~~Designation: A955/A955M-10a~~ Designation: A955/A955M – 11

Standard Specification for Deformed and Plain Stainless-Steel Bars for Concrete Reinforcement¹

FIG. 1 Typical Three-Sided Deformed Bar

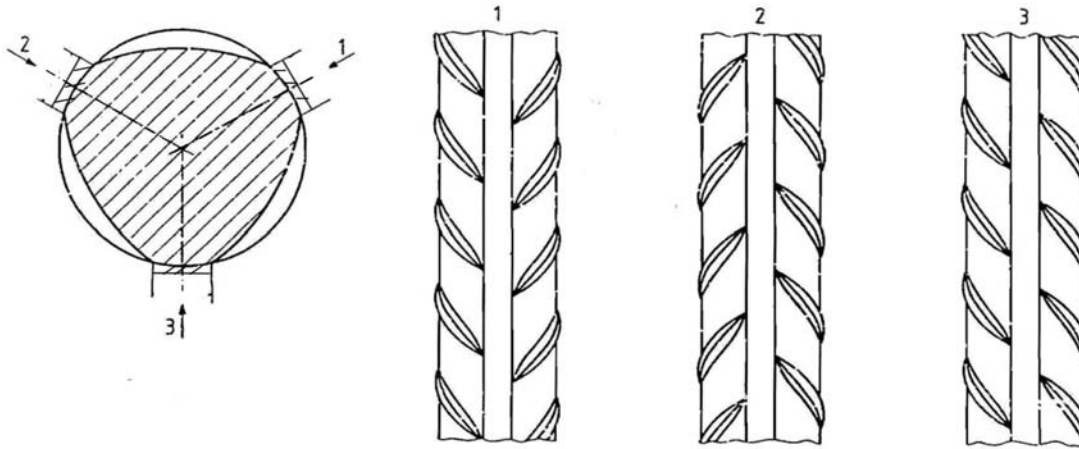
~~1.3~~ Requirements for the relative deformation area of three-sided deformed bars are contained in Annex A4.

3.1.7 *three-sided bar, n*—deformed steel bar with three rows of transverse deformations.

7.2 The deformations shall be placed with respect to the axis of the bar so that the included angle is not less than 45°. Where the line of deformations forms an included angle with the axis of the bar of from 45 to 70° inclusive, the deformations on a two-sided bar shall alternately reverse in direction on each side or those on one side shall be reversed in direction from those on the opposite side. The deformations on three-sided bars shall reverse on one of the three sides (see Fig. 1). Where the line of deformation is over 70°, a reversal in direction is not required.

8.3 For three-sided bars, the relative deformation area, R_d , shall meet the requirements of Annex A4.
